Consultation on Scottish Hydro Electric Transmission's MSIP Re-opener (Beauly Dynamic Line Rating Project)

We¹ are consulting on the needs case and preferred option for Scottish Hydro Electric Transmission's (SHET's) proposal to install a Dynamic Line Rating system on the 275kV north of Beauly circuit from Beauly to Loch Buidhe to Dounreay. We would like views from people with an interest in electricity transmission and distribution networks. We would also welcome responses from other stakeholders and the public.

Figure 1: North of Beauly generation compared to B0 boundary capability

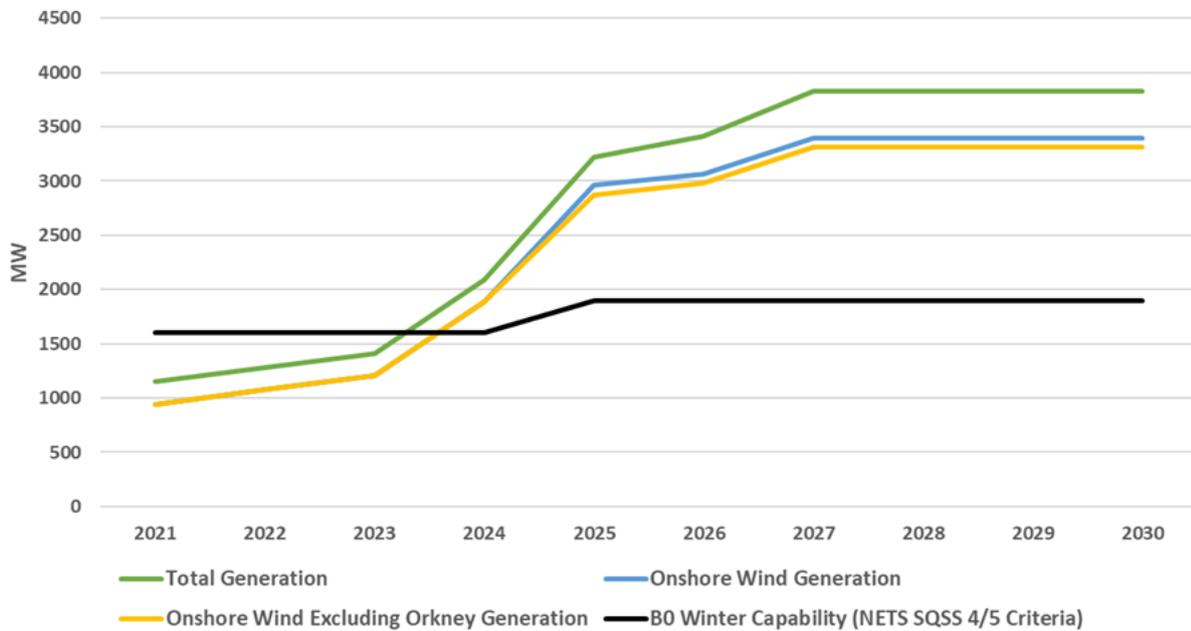
3.8. On the basis of this data, SHET predicts that total generation is predicted to exceed B0 capability in 2024. This would lead to increased annual network constraint costs. SHET consider that intervention is necessary to mitigate constraints before the earliest in-service date of the the proposed Beauly Reinforcement project (2030).

3.9. SHET states that under the criteria relating to winter peak demand, found in Section 4 of the SQSS, the current capability of the B0 boundary is approximately 1GW. This is lower than the capability calculated under the year-round operational criteria, due to the requirement to secure the system under Section 4 winter peak demand criteria against the fault outage of a double circuit OHL. Under year-round operational criteria, the system only needs to be secured against the fault outage of a single circuit.

Figure 2: Required Transfer (MW) according to FES across the B0 boundary

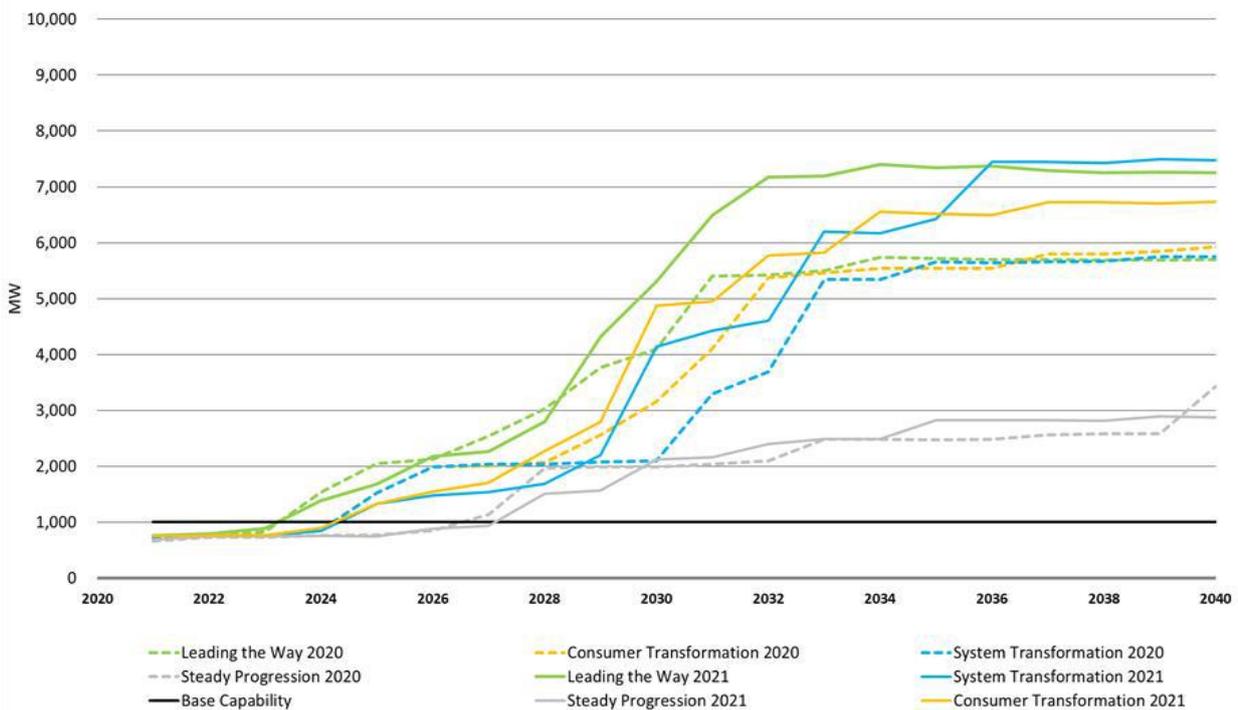
3.11. Similar to Figure 1, which shows that total generation exceeds B0 capability around 2024, Figure 2 indicates that the required transfers exceed B0 capability around 2024 in all GB FES for 2020 and 2021, with the exception of the Steady Progression scenario.

3.12. The three FES scenarios which achieve the target for net zero by 2050 are the Leading the Way, Consumer Transformation and System Transformation scenarios. By 2030, the proposed delivery date of the Beaulieu Reinforcement project, the required transfers for these

three scenarios increase to between 2.1GW and 4.2GW in FES 2020 and between 4.1GW and 5.3GW in FES 2021.

Figure 3: Statistical analysis undertaken to determine seasonal DLR rating for CBA

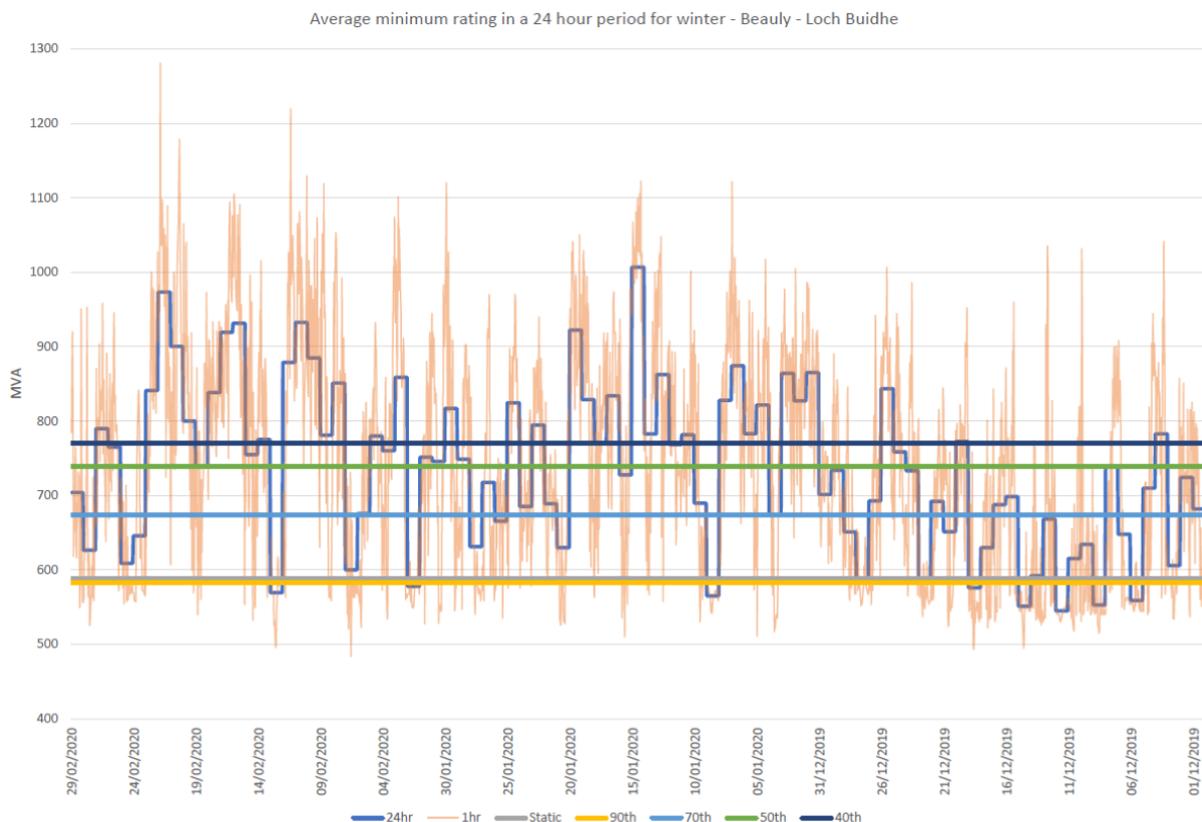
4.23. The median seasonal post-fault rating determined for DLR is 853MVA, 742MVA and 667MVA for the winter, spring/autumn and summer seasons respectively. The outcome of SHET’s analysis is a rating increase of 151MVA, 77MVA and 68MVA respectively (this totals 302MVA, 154MVA and 136MVA for the double circuit OHL), with DLR therefore providing a higher rating increase in the winter, but a lower rating increase in the spring/autumn and summer seasons. This translated in the boundary capability studies to DLR providing an equivalent capability uplift to the re-profiling option in winter, but a lower capability uplift in the other seasons. An example of this analysis has been included below in Figure 3.

4.24. For the combination of DLR and re-profiling option (i.e. Option 4), SHET applied the rating increase calculated through the statistical analysis exemplified in Figure 3 in addition to

the rating increase provided by the re-profiling option. This resulted in a seasonal rating of 965MVA, 854MVA and 782MVA for winter, spring/autumn and summer respectively.
